**P802.3dj Physical layer jitter (Clause 176/179) proposal to advance/close current comments against present JRMS and J4u03 methodologies Presented to IEEE P802.3dj Electrical Task Force January 2025.  
Version 1.2: January 23, 2025**

**Abstract: Comments recorded against P802.3dj D1.3 (306, 219, 220, 221) are calling out for improved handling of jitter. Based on the straw-polling of gines\_3dj\_optx\_01a\_250109.pdf conducted on 01/09/2025 this contribution drives to addressing these comments**

## Comment 306:

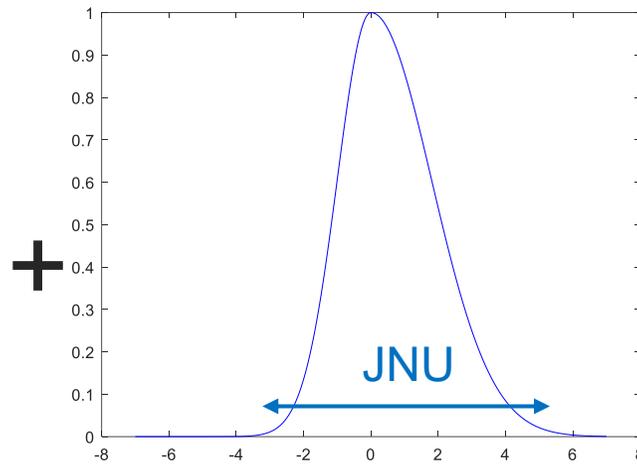
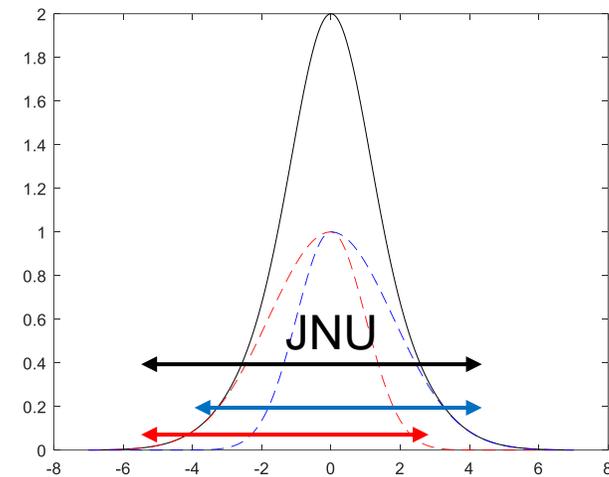
Jitter measurements refer to 120D.3.1.8.1 for the probability distribution calculation method... The method of combining the distributions should be improved to mitigate additive noise and slope dependence.

The composite histogram can have a higher JNU value than the sum of individual JNU values when histograms are not symmetric. This example shows a long tail to the left for rising, and a long tail to the right for falling edges. An additional influence on the symmetry of these distributions is biased by the pre-transition and post-transition run-length.

## Comment 306:

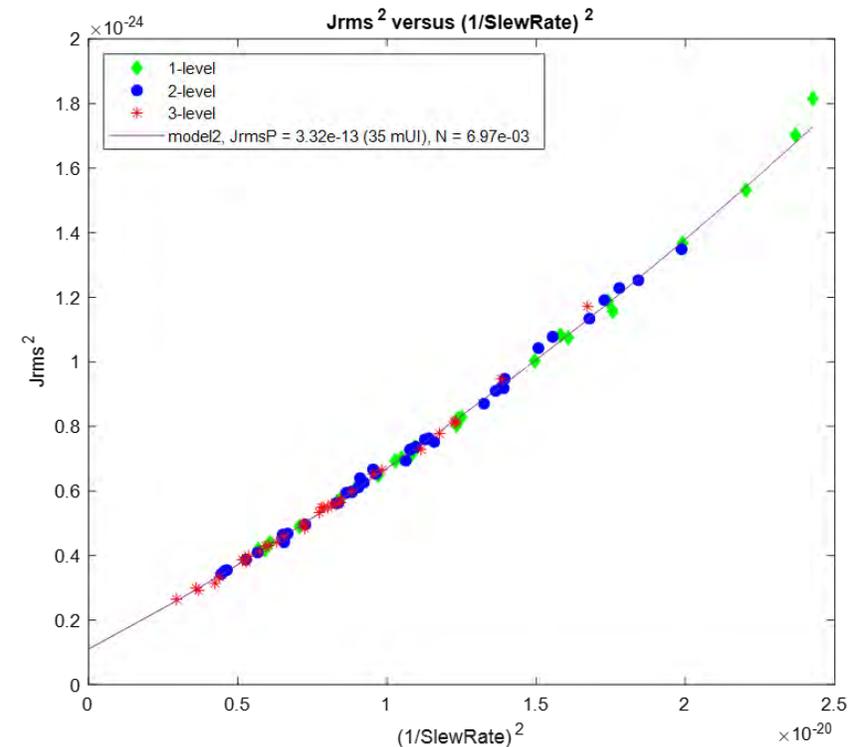
Jitter measurements refer to 120D.3.1.8.1 for the probability distribution calculation method... The method of combining the distributions should be improved to mitigate additive noise and slope dependence.

- As illustrated in [calvin\\_3dj\\_01b\\_2407](#) Pg 7, the process of “combining the sets” results a composite result that is substantially greater than the sum of its parts.
- Rising edge J<sub>nu</sub> histograms have a “left” bias, and corresponding falling edge histograms have a “right” bias. “Combining” or adding these two histograms into a composite value has always been problematic.
- It is recommended that within a given transition level class (e.g. 3 level transitions) that the J4u/J3u value be associated with the **RMS (root mean squared)** of the individual measured values

## Q-Scale and Jitter components (Rj only)

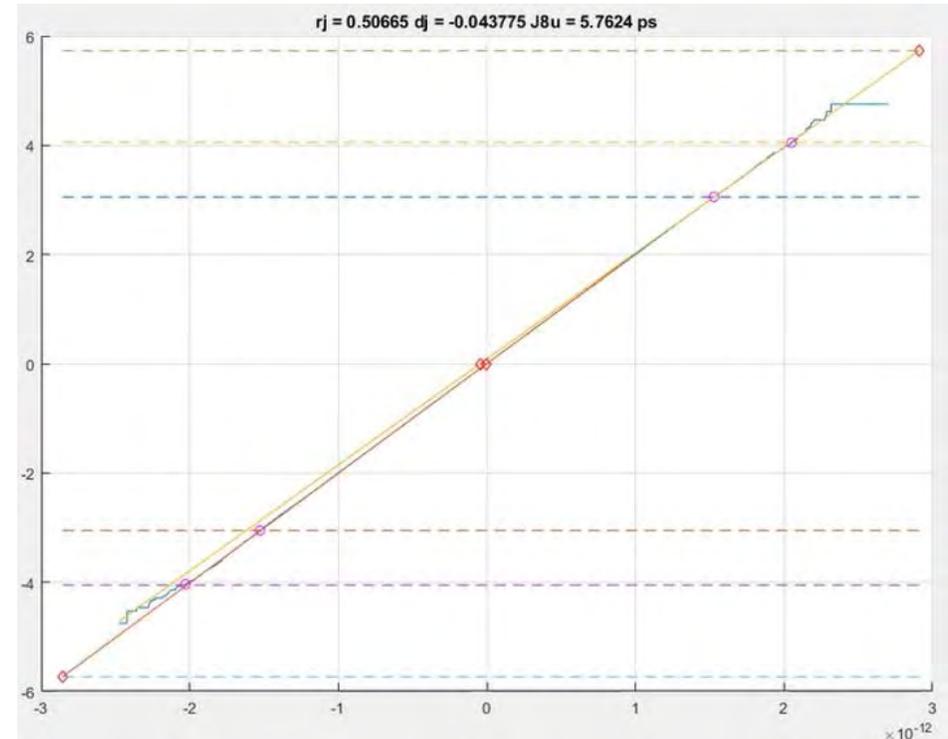
J3u and JRMS measurements at TP2 are highly affected by the effects of slew rate and noise and do not reflect actual uncorrelated jitter.. A different methodology that will better quantify phase-only uncorrelated jitter has to be explored

- The Q-Scale transform offers a method of transforming a probability distribution into Q-Space
- It's an effective means to both determine how Gaussian a distribution is, and to predict lower probability behavior.

# RJ Compensation 12-edge Synthetic 5mv RN,40mUI DJ, 31dB Channel 0RJ

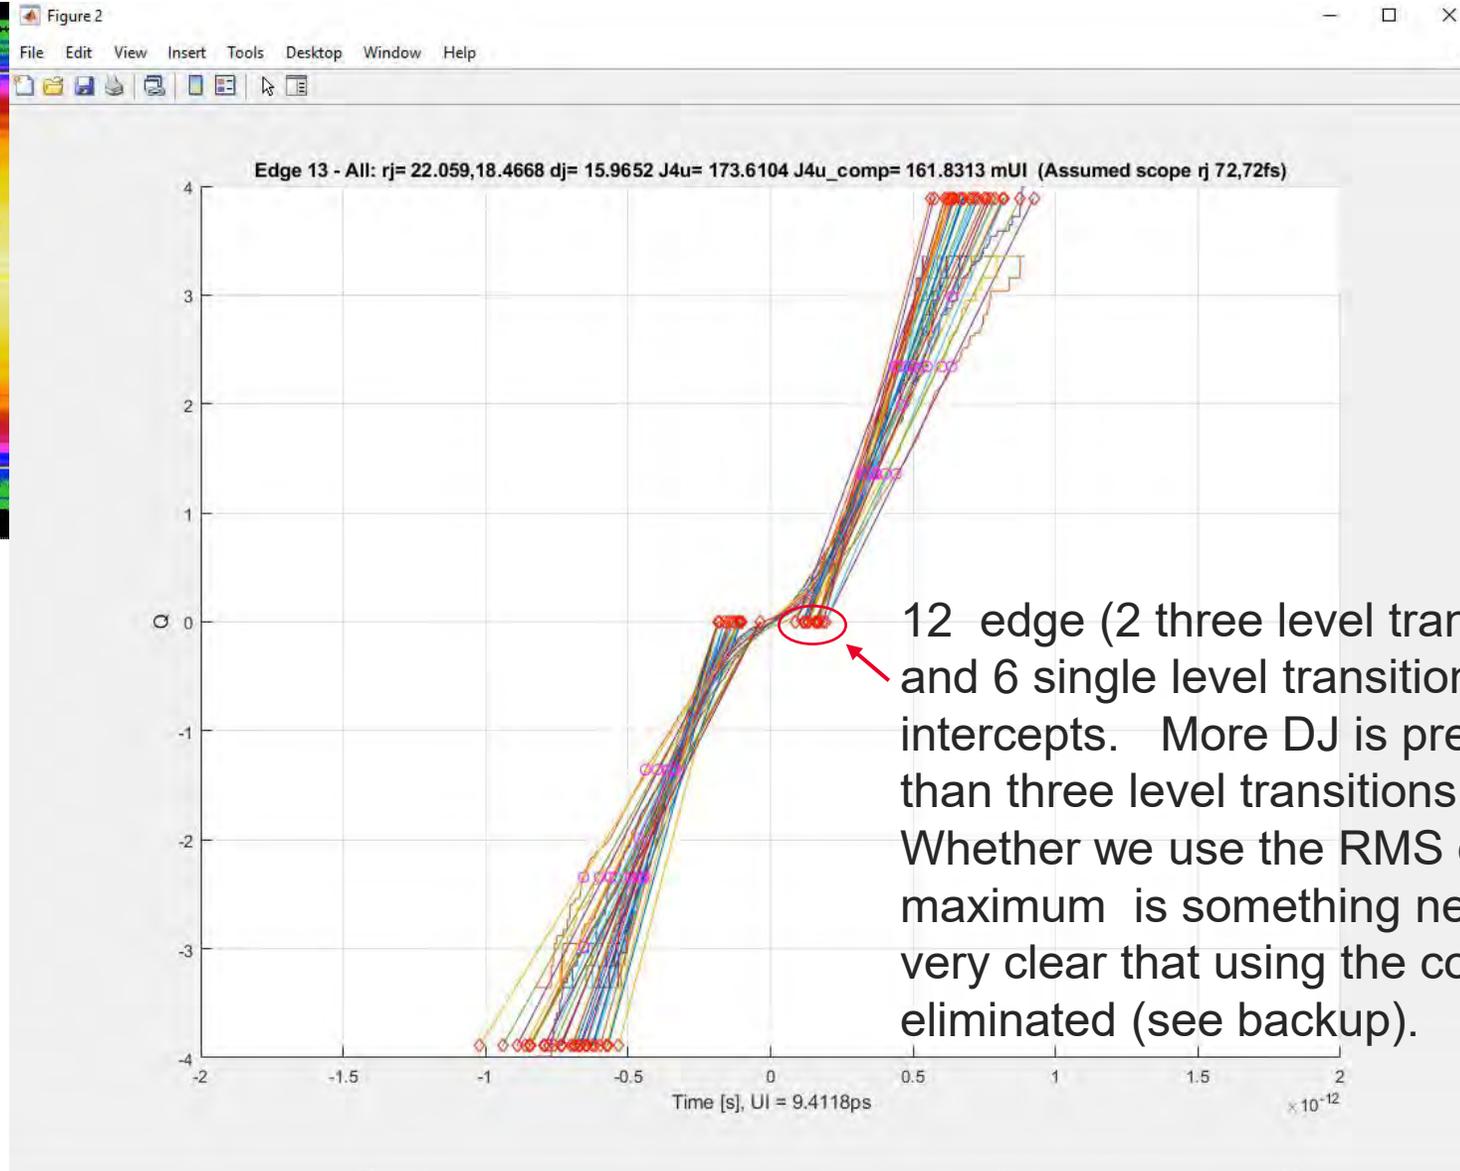
12 edge (2 three level transitions, 4 two level transitions and 6 single level transitions) provide a distribution of x-intercepts. More DJ is present in single level transitions than three level transitions. Whether we use the RMS of these DJ intercepts, or maximum is something needing research. One thing is very clear that using the composite edge needs to be eliminated (see backup).

## Comments 540, 541:

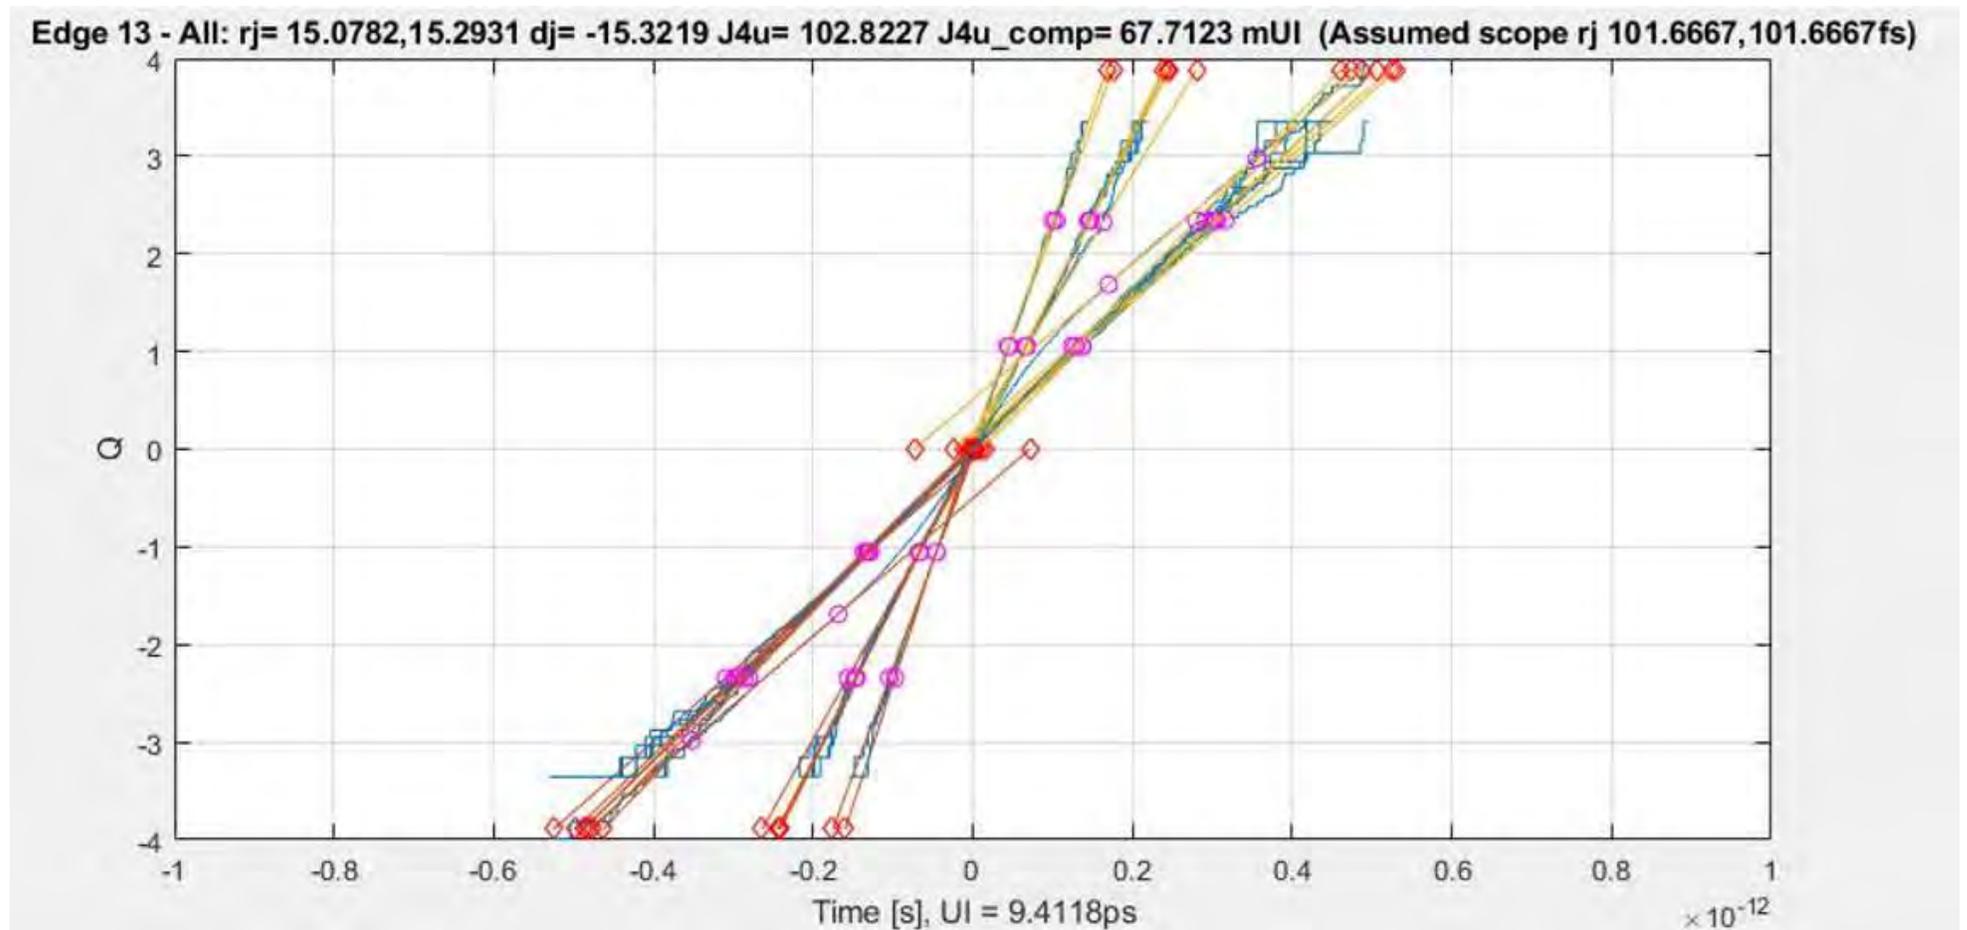
As already pointed out, the "jitter measurement" method here doesn't work for the relevant bandwidths, losses and amplitudes. This is particularly obvious for J3u03; J4u03 seems to be beyond the state of the art. EOJ should be part of an eye spec like EECQ, not a separate spec item.

Regarding the “relevant Bandwidths and losses” there is real concern that a Via has a filter cutoff well below the 60GHz 4BT prescribed by the current post Via bandwidth in [rabinovich 3dj 01 230116](#)

[calvin 3dj 01b 2407.pdf](#) (Pg 16) illustrates the impact of lower BW filter selections on Jitter relative to the specified 60GHz 4BT outlined in clause 178.9.2. The empirical data supports that the 60GHz 4BT does provide the lowest jitter values.

[calvin 3dj 01b 2407.pdf](#) (Pg 7) Suggested that the reported EOJ03 should be the **RMS (root mean squared)** of the two (0->3, 3->0) three level EOJ values.
